Model	VT2100/2130/2150, Ges5310/5315/5320, Rex1240/1241/1242, NSA CP310/315	Volt/Hz	Date of Modification	Serial Number
Modified Article	Parts Catalog			
Reason for Modification	Parts catalog correction

Model		VT2100/2130/2150, Ges5310/5315/5320, Res1240/1241/1242, NSA310/315					Volt/Hz	Date of Modification	Serial Number	
Modified Article		2nd Feed Roller Gear								
Reason for Modification		To improve the durability of the 2nd feed roller gear								
Draw No.	Old Parts No.	New Parts No.	Description	A.B.C.	Q'ty Used Old → New	Inter-change-ability	Part needed for replacement by new part		Parts Catalog	
				Rank			Part No.	Description	Index No.	Page
	C2035231	C2075231	Gear - 14T			X/O			12	27

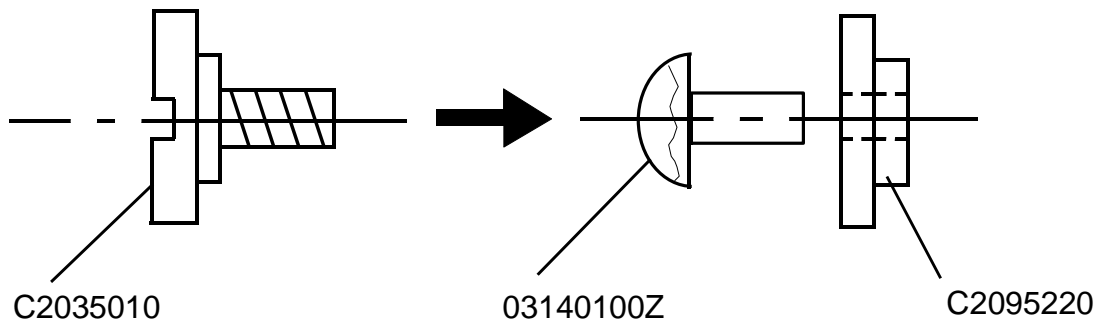
Model	VT2100/2130/2150, Ges5310/5315/5320, Rex1240, 1241, 1242, NSA CP310/315	Volt/Hz	Date of Modification	Serial Number
Modified Article	Lever Shaft			
Reason for Modification	To facilitate servicing

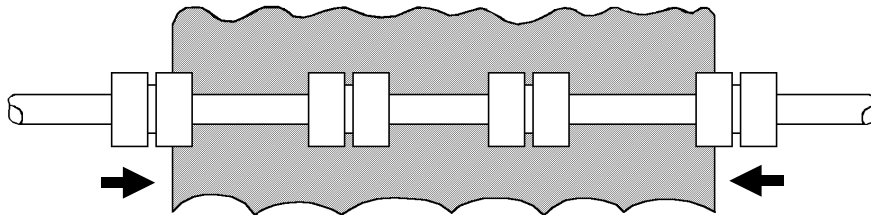
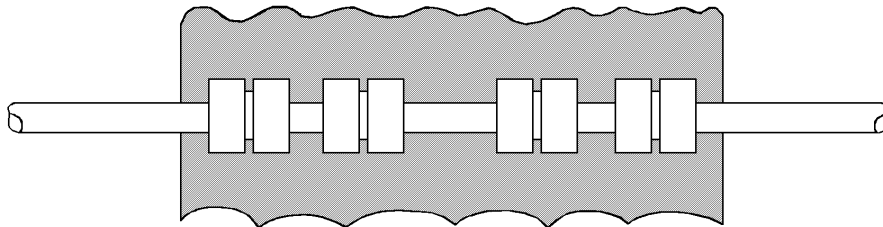
There are 4 sets of master eject rollers and belts. In the A4 or 8 1/2" 14" size master version machines, both sides of the 4 sets do not catch the master edges sufficiently while transporting it. Even with this mechanism, used masters can usually be ejected properly. However, when a master eject jam occurs in this area, the jammed master tends to be creased among the rollers and belts. In the worst case, the master eject belt will slip off when the operator roughly removes the creased and jammed master.

To prevent this, both sides of the 4 sets of the master eject rollers and belts have been moved more inward 20 mm so that they can catch the master more sufficiently (just like the B4 size master version machines). To do this, the following changes have been implemented.

- 1) To move the 2 outside second lower eject rollers inward, the bottom plate of the master eject unit (# C2033527) has been changed. (The guides for the 2 rollers, which are fixed to the bottom plate, have been moved.)
- 2) To move the 2 outside of the first upper and lower eject rollers to inward, the assembled first upper and lower eject rollers (# C2003539 and # C2003542) have been changed.
- 3) To move the 2 outside second upper eject rollers inward, the positions of the grooves for the E-rings that fix the rollers on the shaft (# C2013530) have been moved.

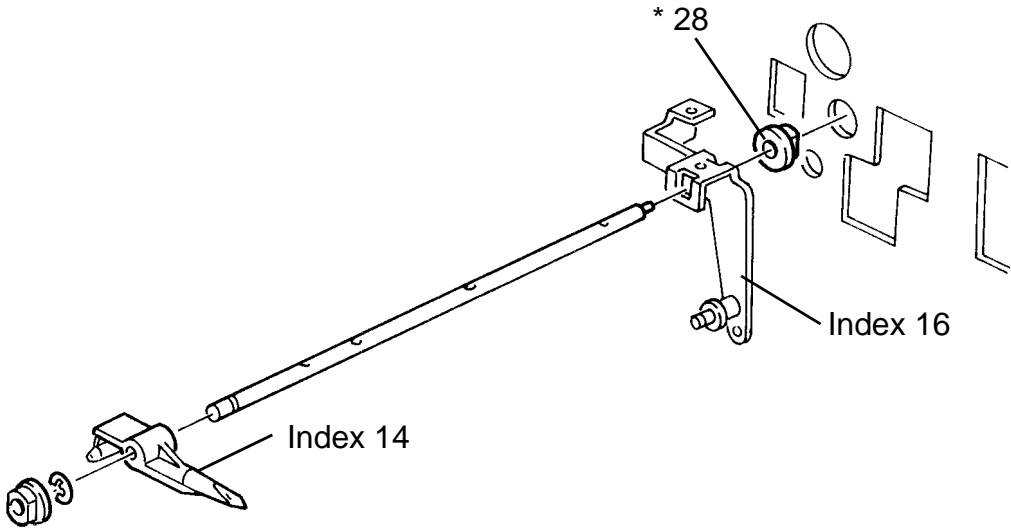
Add the following part:

New Index	Part Number	Description	Q'ty
28	C2032083	Exit Pawl Bushing	1

Page 54 PLOTTER / MASTER FEED SECTION II

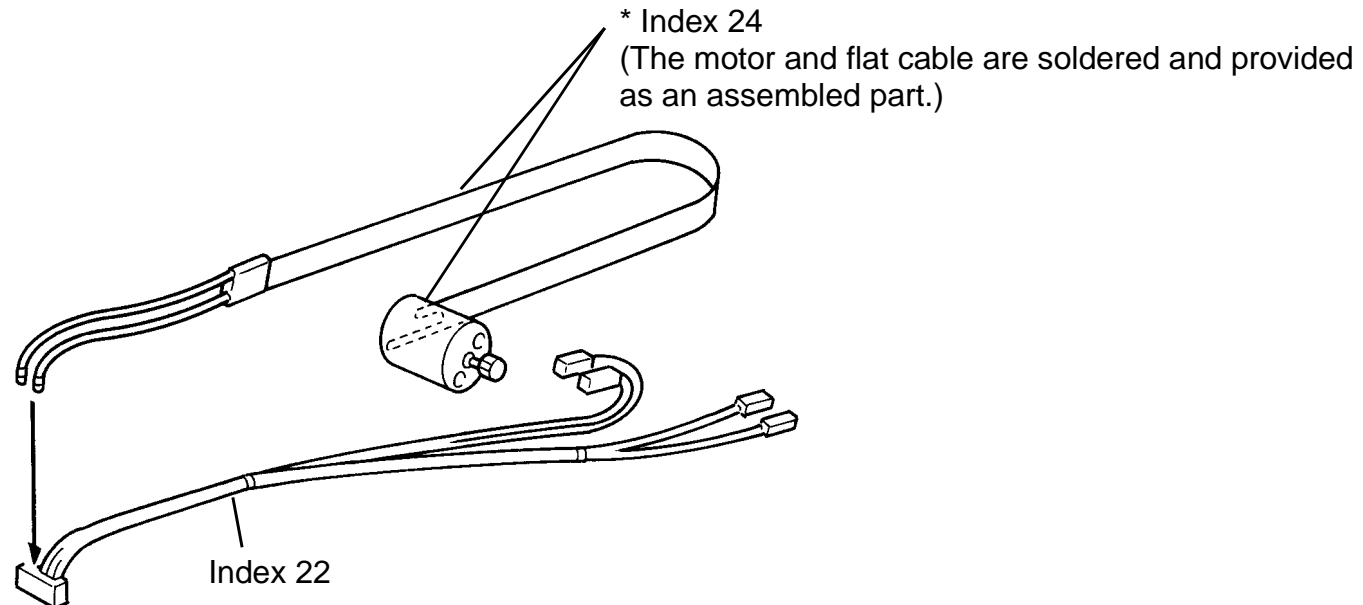
Correct the illustration for the cutter motor (C2008415) as follows:

Page 57 PLOTTER / MASTER FEED SECTION III

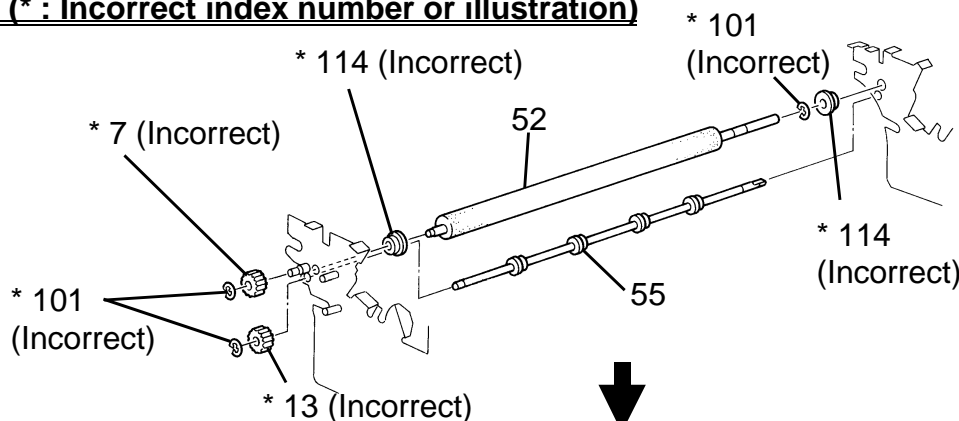
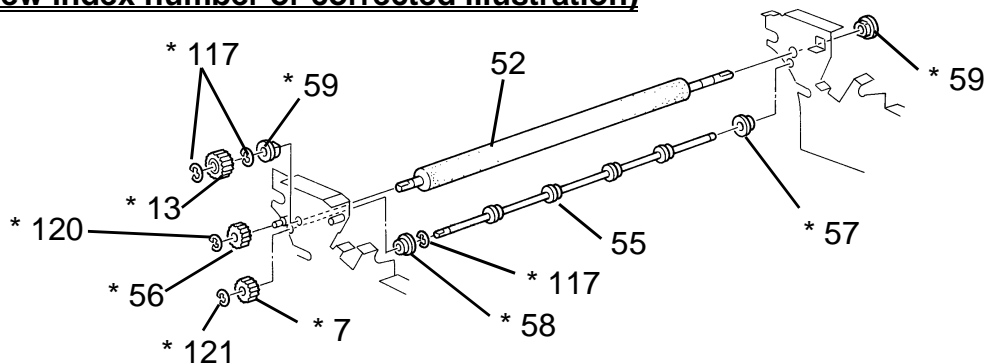
Add the following parts and correct the illustration as shown below:

New Index	P/N	Description	Q'ty
56	C2002338	Gear - 20T	1
57	53241658	Bushing - 4 x 8 x 4.5 mm	1
58	H0022226	Bushing - Head Roller	1
59	H0121181	Bushing - M6	2
120	07200020Z	Retaining Ring - M2	1
121	07200025Z	Retaining Ring - M2.5	1

Drawing No. 1

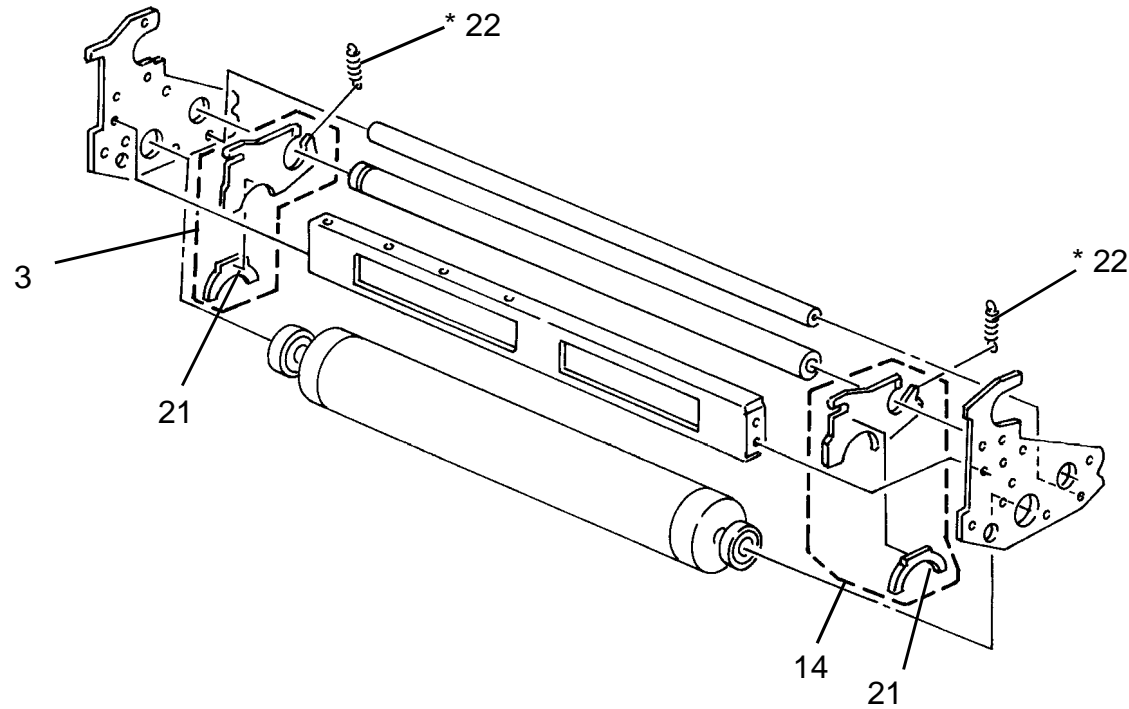
Model		VT2100 / 2130 / 2150, Ges 5310 / 5315 / 5320, Rex 1240 / 1241 / 1242, NSA CP310 / 315					Volt/Hz	Date of Modification	Serial Number	
Modified Article										
Reason for Modification		Due to parts standardization with other models								
Draw No.	Old Parts No.	New Parts No.	Description	Rank	Q'ty Used Old→New	Inter-changeability	Parts needed for replacement by new part		Parts Catalog	
							Part No.	Description	No.	Page
	C2002005	C2222072	Bottom Stay		2 → 2	O/O			11	11
	C2032015		Bracket		1 → 0					
		C2242015	Image Processing Board Bracket		0 → 1	O/O			13	11
	C2002340		Washer		1 → 0					
		07010030Z	Flat Washer - M3		0 → 1	O/O			24	13
	C2012226	C2192226	Gear - 22T		1 → 1	O/O			33	13

Draw No.	Old Parts No.	New Parts No.	Description	Rank	Q'ty Used Old → New	Inter-changeability	Part needed for replacement by new part		Parts Catalog	
							Part No.	Description	No.	Page
	C2005207	C2195127	Sector gear Stud		1 → 1	X/X		O/O as a set	3	25
	C2035175	C2245101	Sector Gear		1 → 1	X/X			5	25
	55015929		Spacer - 5.2 mm x 16 mm x 1		1 → 0				1	25
	56001086		Spacer - 10.2 x 20		1 → 0				6	25
	08077018		Washer - M10		3 → 0				104	25
	07200080Z		Retaining Ring - M8		n → n-1				106	25
	55054189	C2156110	Felt - Side Plate		1 → 1	O/O		24	37	
	C2074948	C2194948	Drum Clamper Ass'y		1 → 1	O/O		12	41	
	C2004941	C2194941	Clamper Shaft		1 → 1	O/O		30	41	
	C2004947	C2224947	Clamper Rubber		2 → 2	O/O		31	41	
	C2074950	C2154950	Drum Clamper Base Ass'y		1 → 1	O/O		32	41	
	C2134583		Stainless Screen - B4		1 → 0					
		C2194583	Tetron Screen - B4		0 → 1	O/O		36	41
